CITY OF West Linn

STAFF REPORT FOR THE PLANNING COMMISSION

FILE NUMBER: SUB-13-05

REQUEST: 4-lot subdivision at 4997 Summit St.

DATE	1/13/14
LAND USE #	
TAX LOT #	251E25DB 500
DESIGNED BY	BF
CHECKED BY	BF
SHEET TITLE	
SUB. DIV. PLAT - PH 1	
SHEET NUMBER	
C2.0

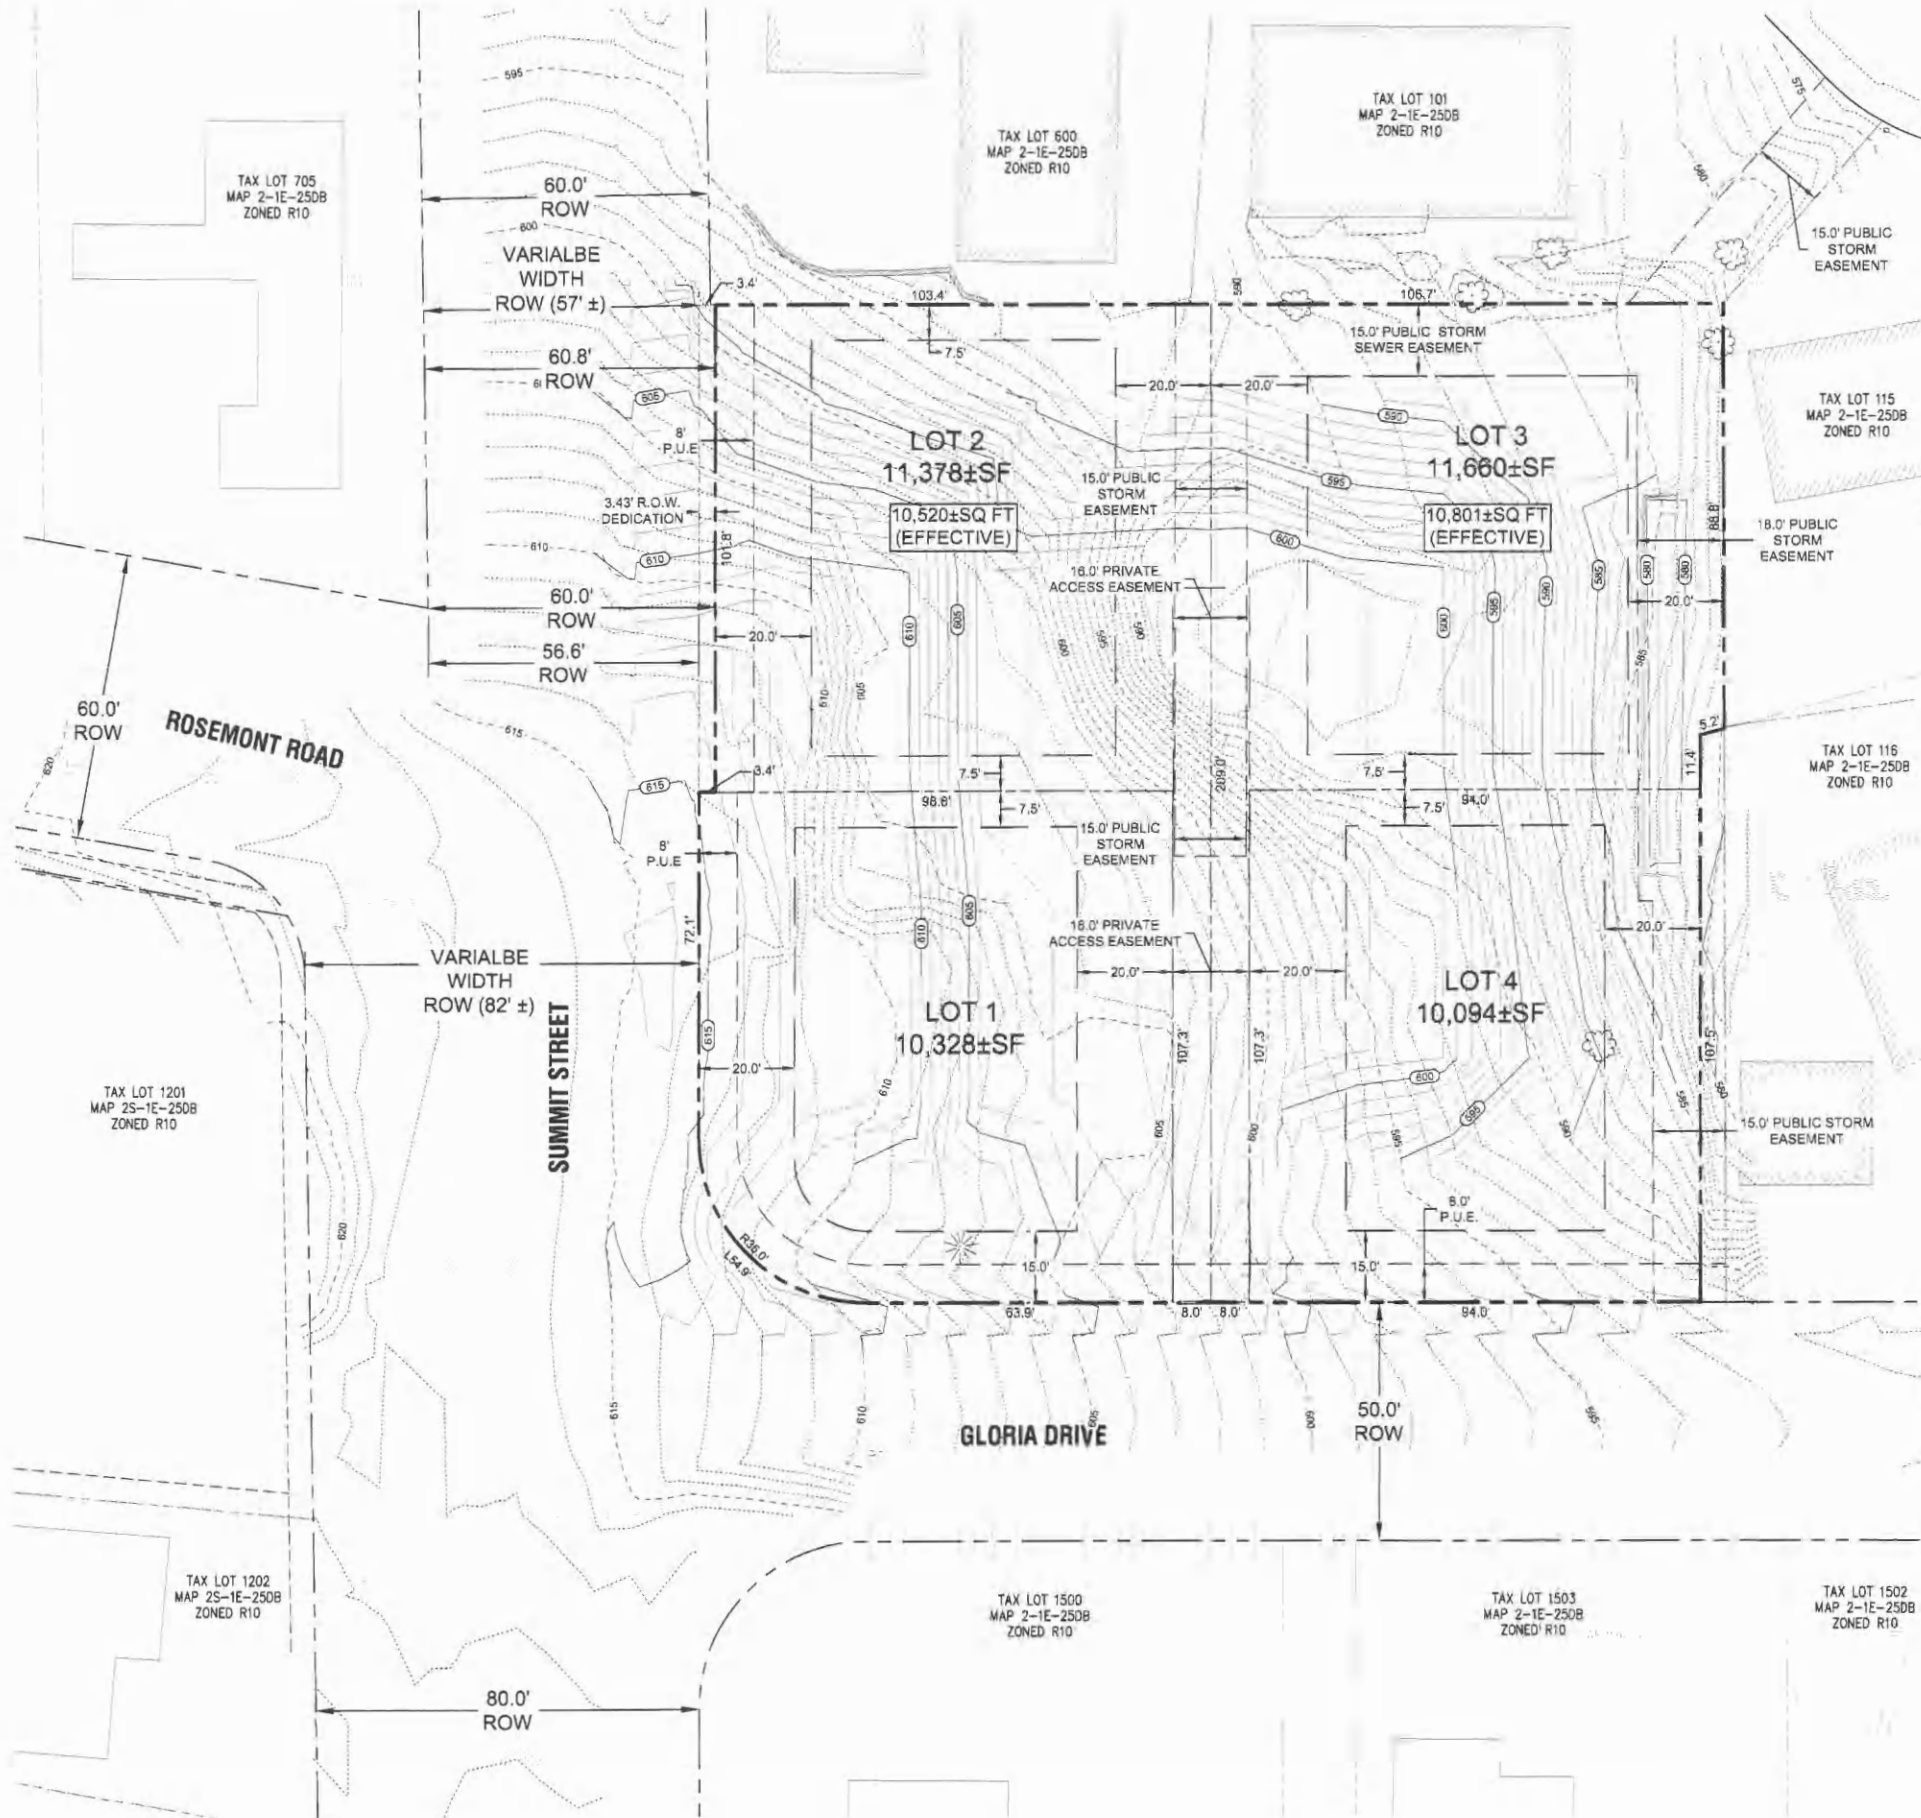
1. Site Plan. With the exception of modifications required by these conditions, the project shall conform to the Subdivision Plat- Phase 1, Sheet C2.0, dated January 28, 2014, located on Page 47 of Exhibit PC-4. If proof of applicant ownership of the hiatus strip between this property and the property to the northeast is provided by the time of final platting, the final plat may then conform to the Subdivision Plat- Phase 2, Sheet C2.0A, dated January 28, 2014 located on Page 48 of Exhibit PC-4.

COA 1 requires compliance with the submitted site plan and tentative plats except for what is modified for code compliance via other conditions.

C2.0A

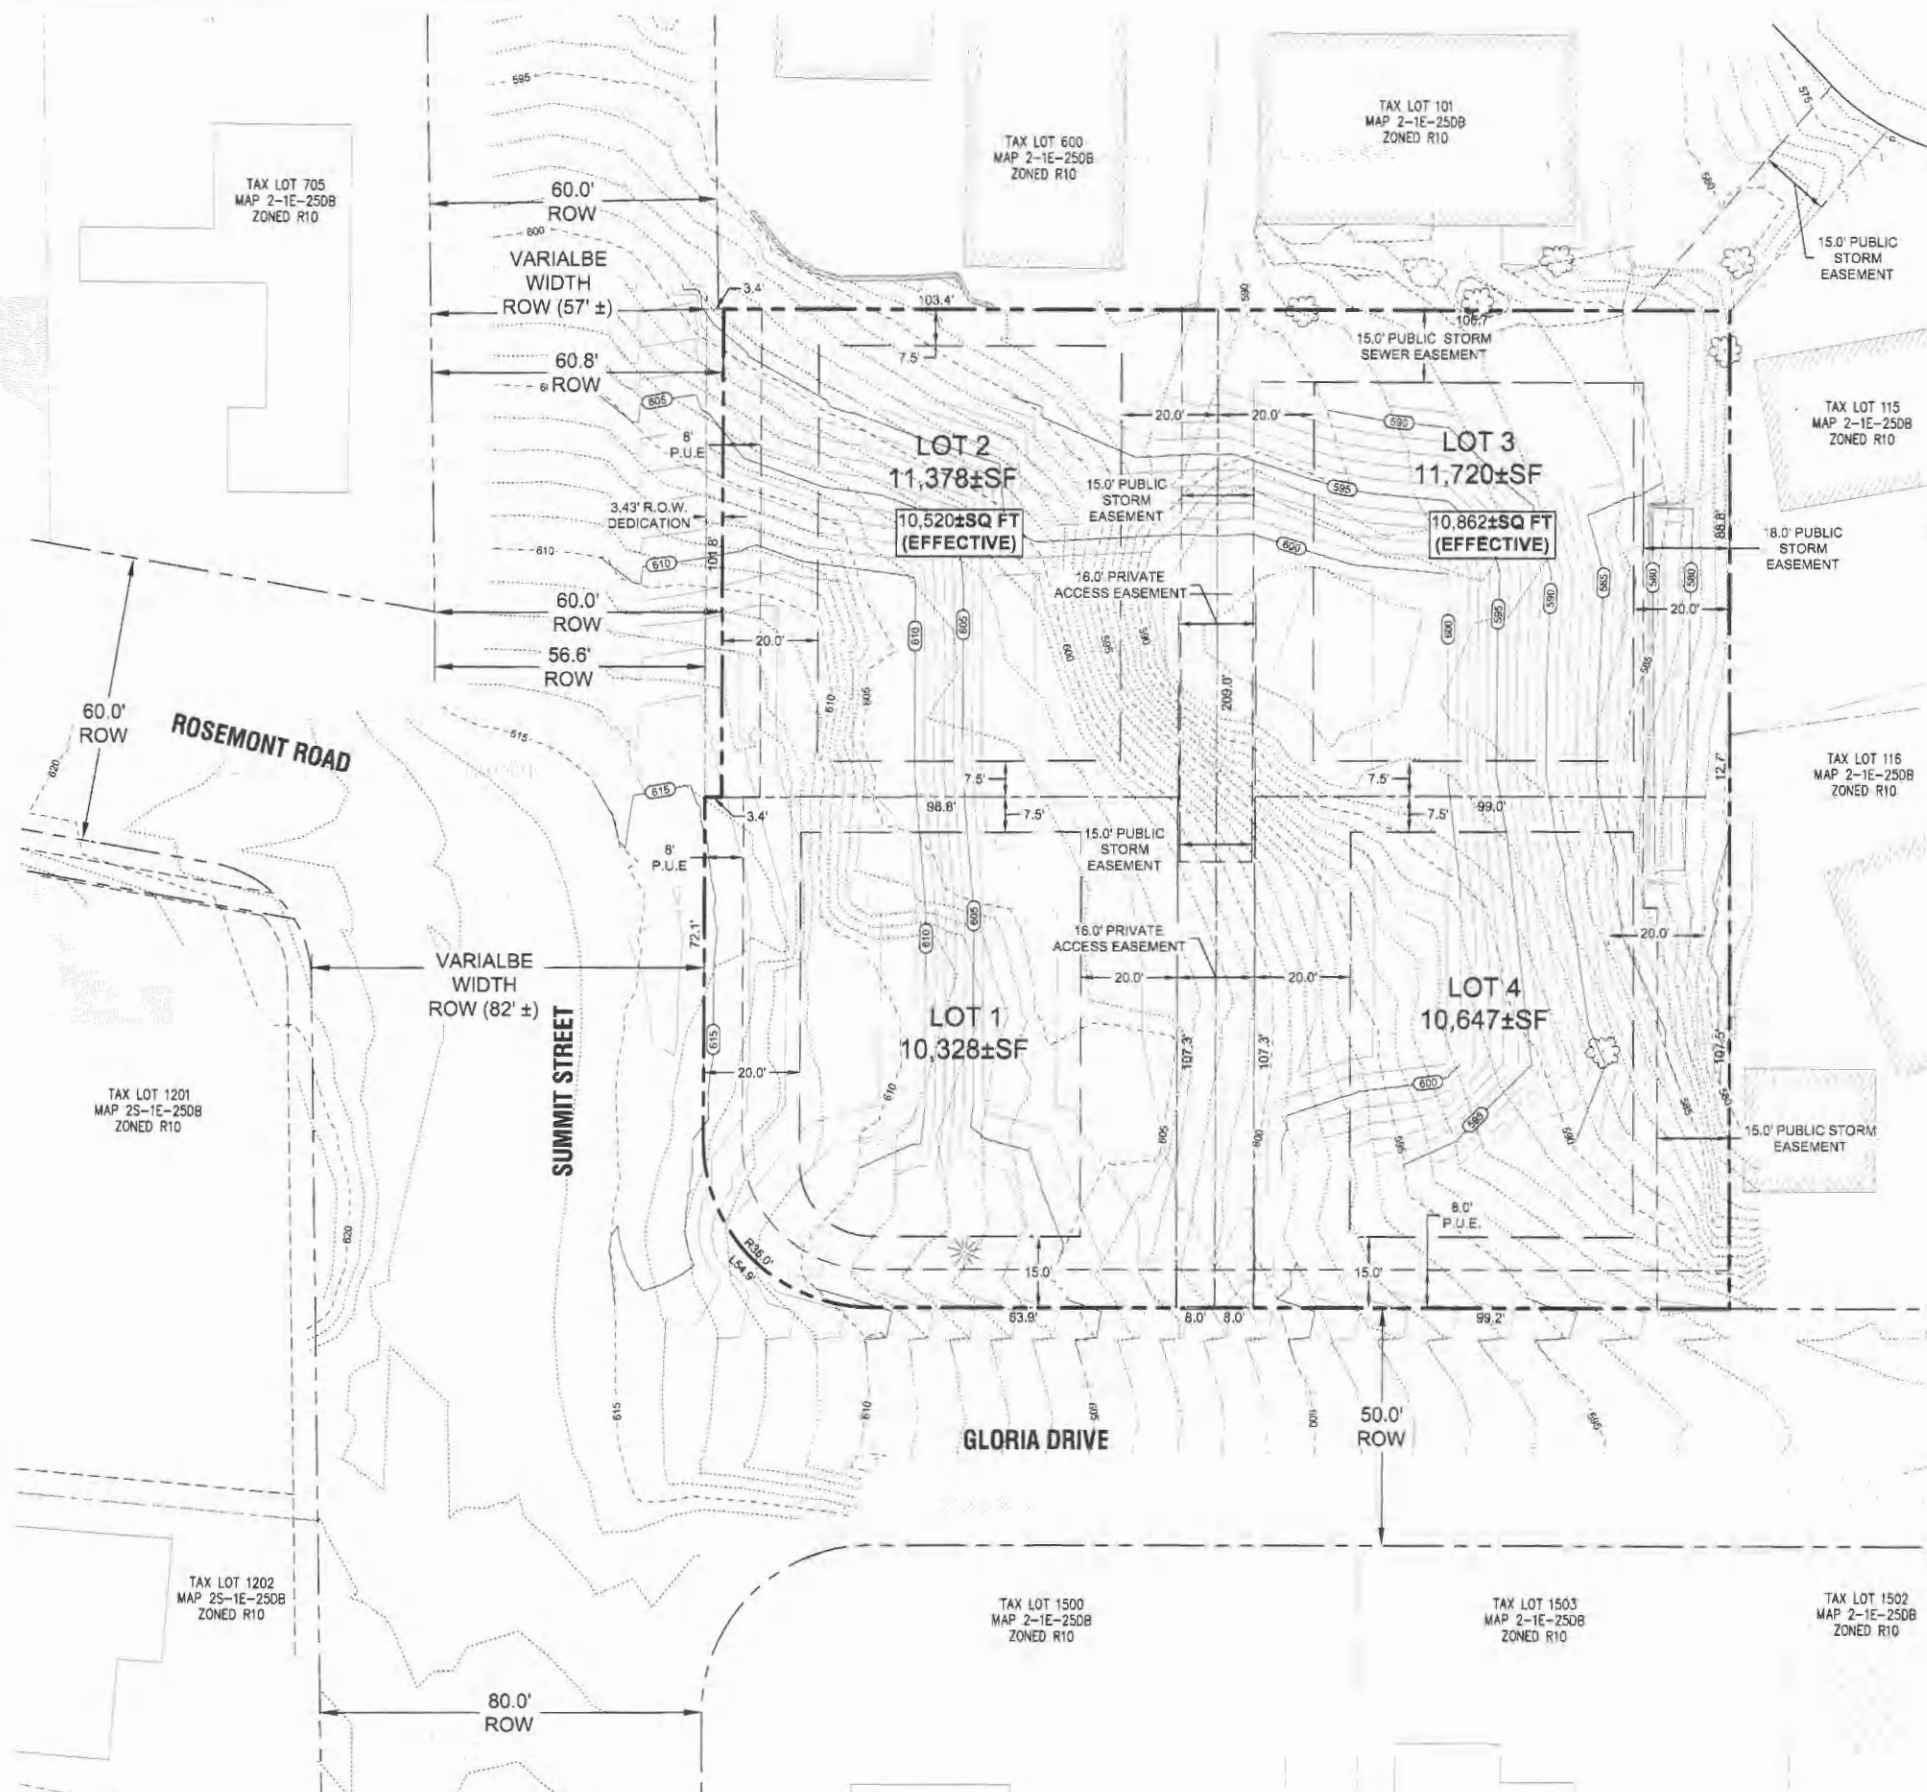
8. Stormwater.
 - A) Prior to recording the final plat, the applicant shall record the proposed stormwater easement on the property at 2630 Woodsprite Court as shown on the Subdivision Plat Sheet C2.0 and Subdivision Plat Sheet C2.0A, Page 47-48 of Exhibit PC-4.
